Car Stereo Service Bulletin

Model: CDX-6020/-6060,-R77, -R79

No. 170R1

Subject: Part Number Correction

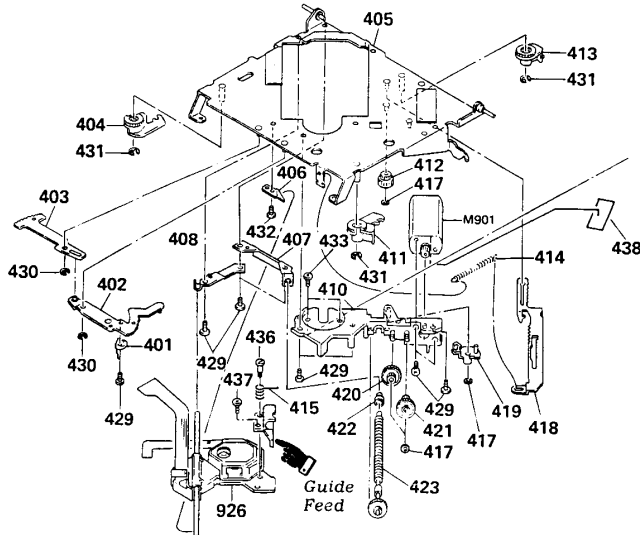
The part number for the guide feed is incorrect.

Solution: Please correct your service manual with the part number listed below:

Ref. No.	Description	Part Number	
		Incorrect	Correct
	Guide, Feed	2-640-654-03	2-643-412-02
